ADDENDUM #1

SACRAMENTO COMMUNITY CENTER COMPLEX

13th and 14th Streets,  
J and L Streets,  
Sacramento, California

ADDENDUM NO. 1  
ITEM #12  
BALCONY GRAB BARS

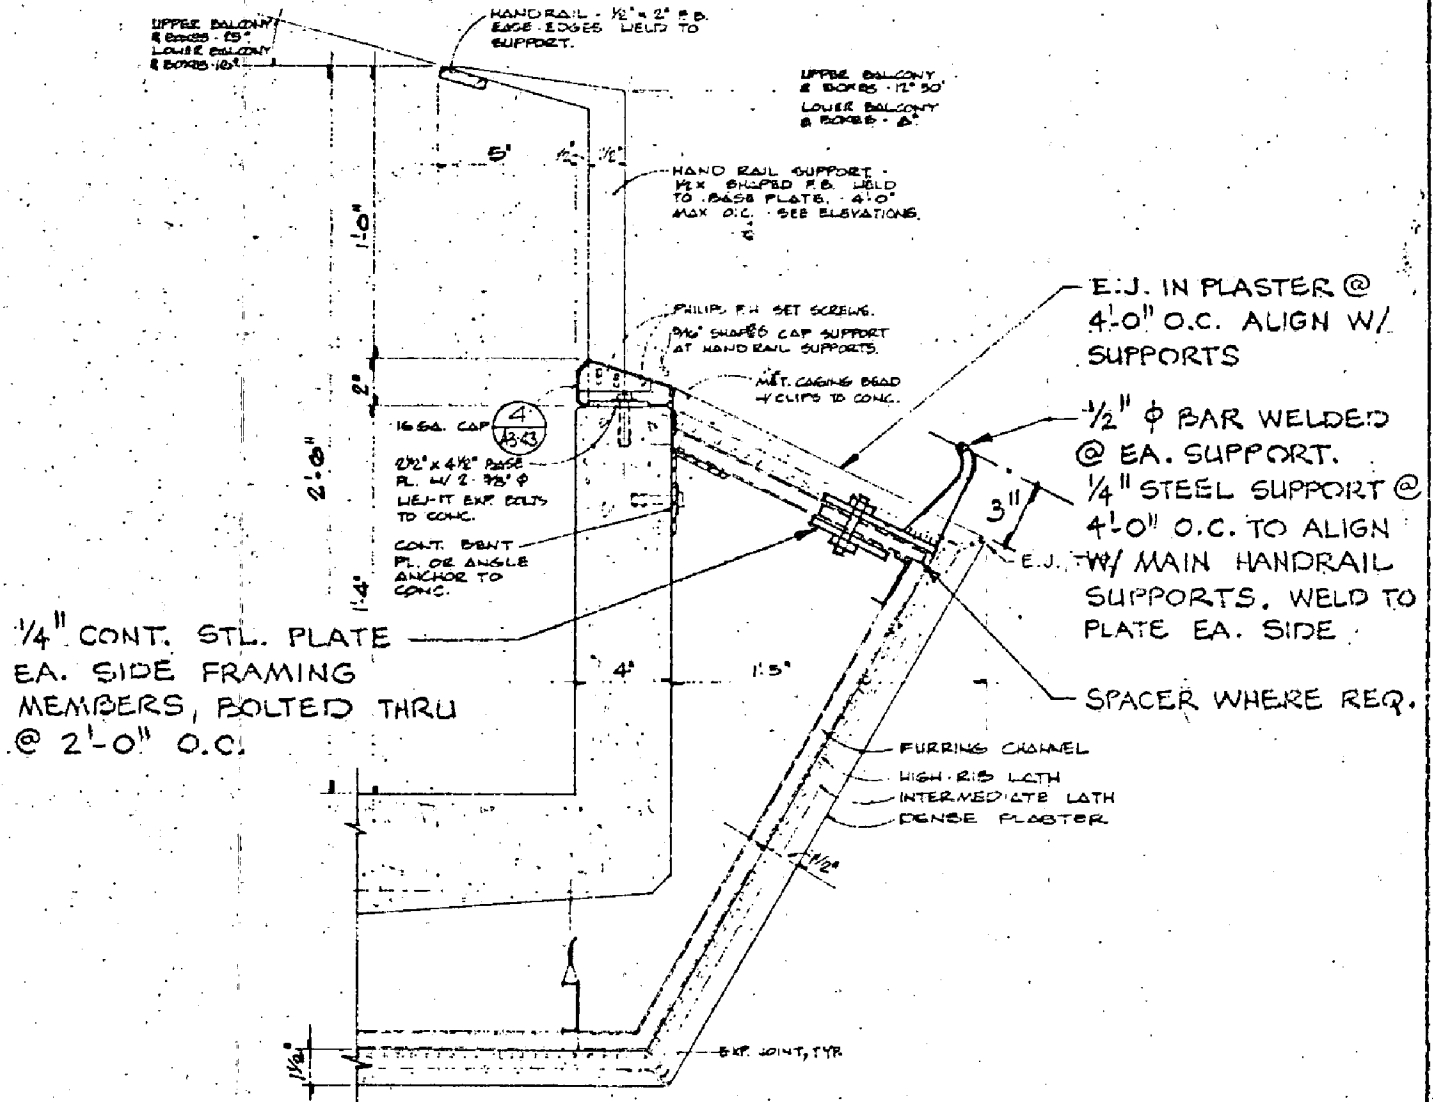
BALCONY GRAB BARS

Reference: Drawings - Sheet A3-43  
Addenda Drawing No. 1  
Specifications - Volume I  
SECTION 5E - MISCELLANEOUS METAL  
Page 5E-1

"Delete Detail 1 on Sheet A3-43." Replace that detail with  
Addenda Drawing No. 1.

Include material under Handrails and Railings in Section 5E.

ADDENDUM NO. 1  
ITEM # 13  
VERTICAL SHAFT COVER

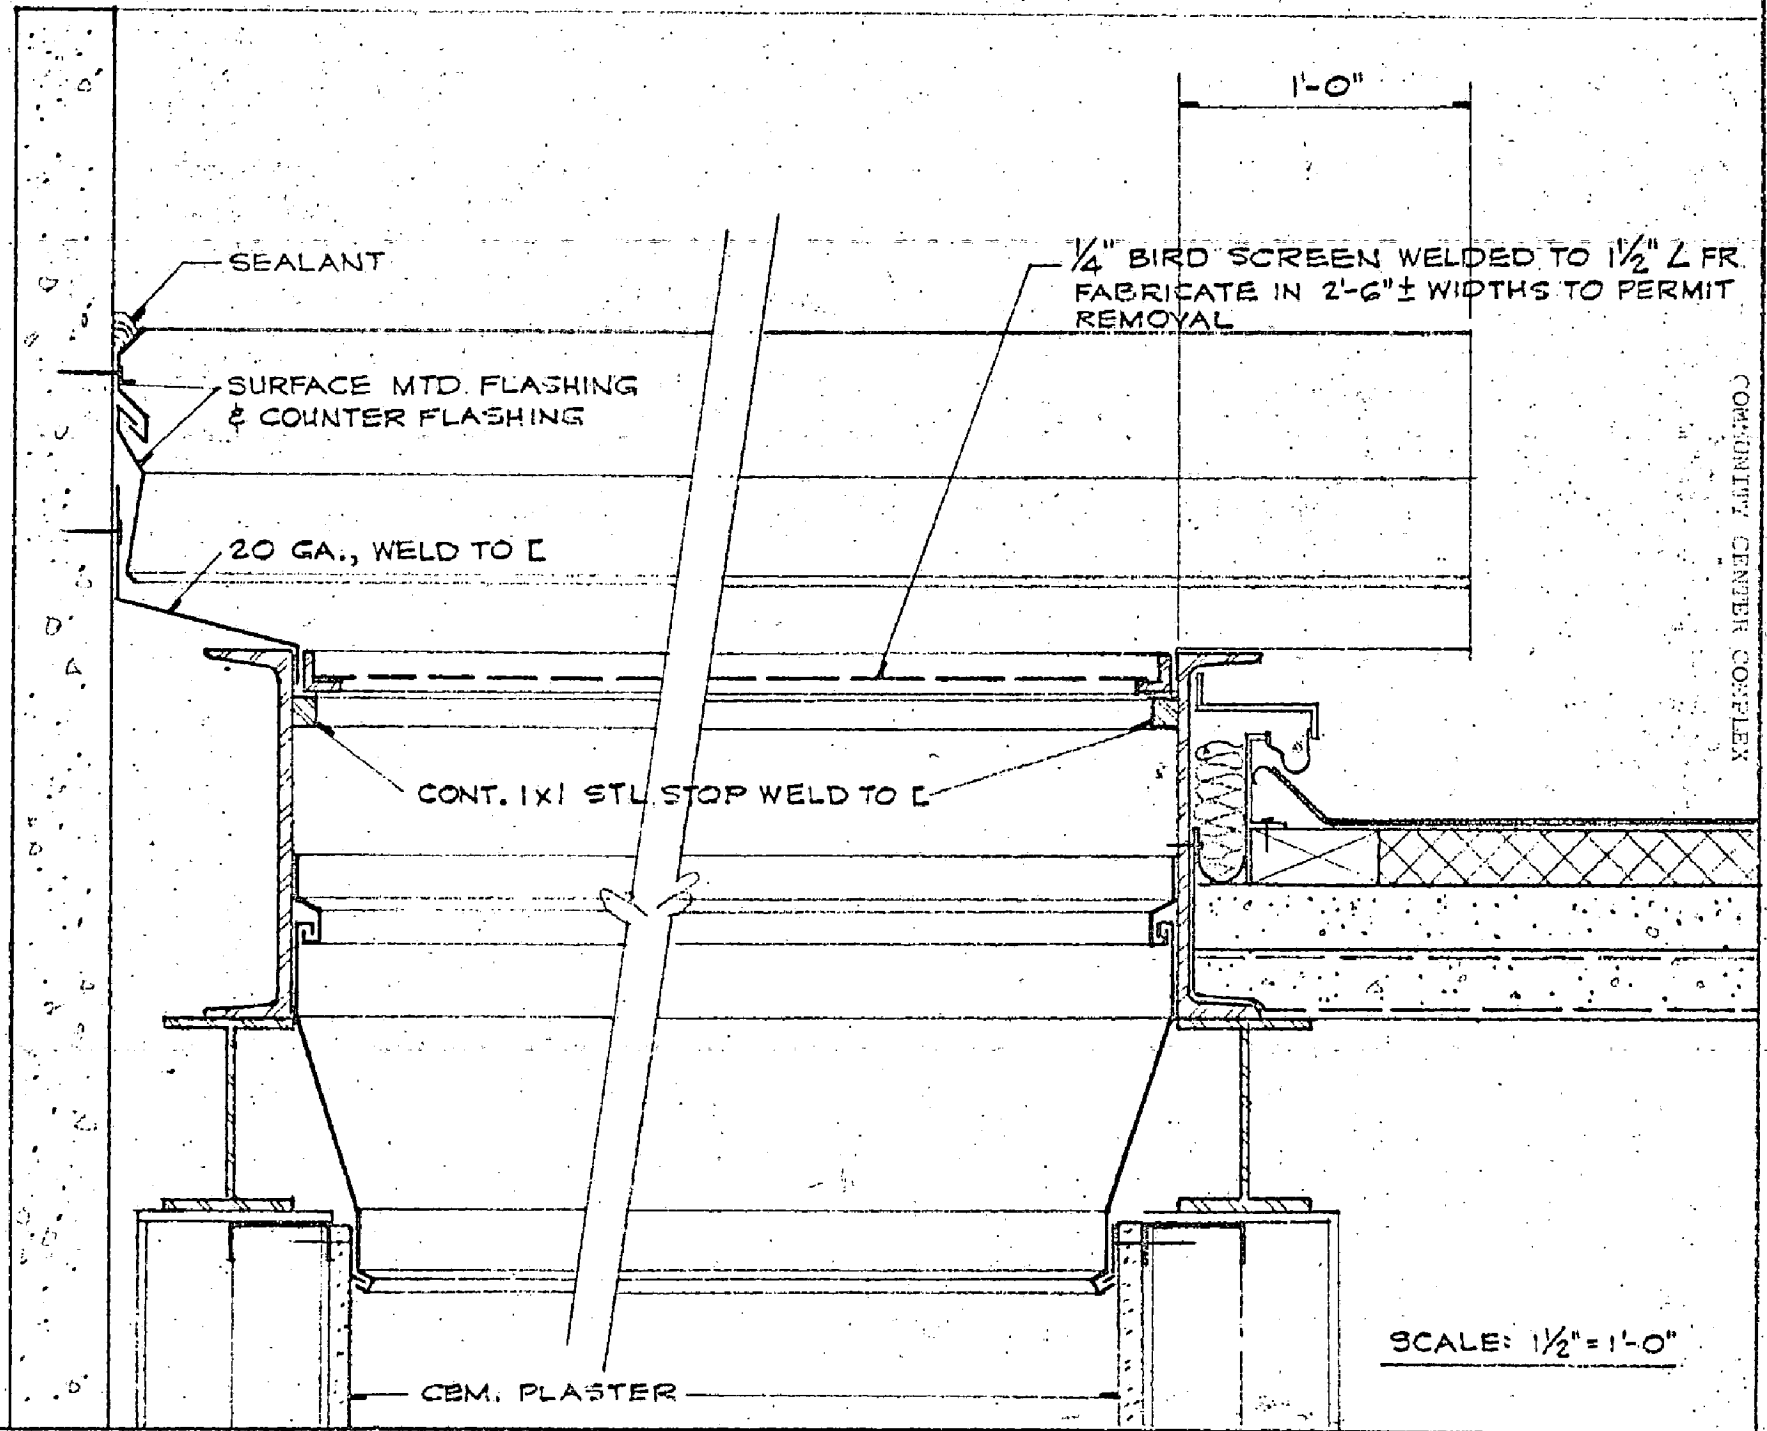
Drawings - Sheet A3-7  
Addenda Drawing No. 2

"Modify Section B of Sheet A3-7, vertical shafts 04 and 09,  
to conform to Addenda Drawing No. 2"

Add Line 33: "1/4" galvanized bird screen"

Addenda Drawing No. 2  
Drawings - Sheet No. AF-5 and No. AF-6

Change wall material at shafts 04 and 09 from Hard Coat Plaster  
as shown to cement plaster system shown in Addenda drawing.
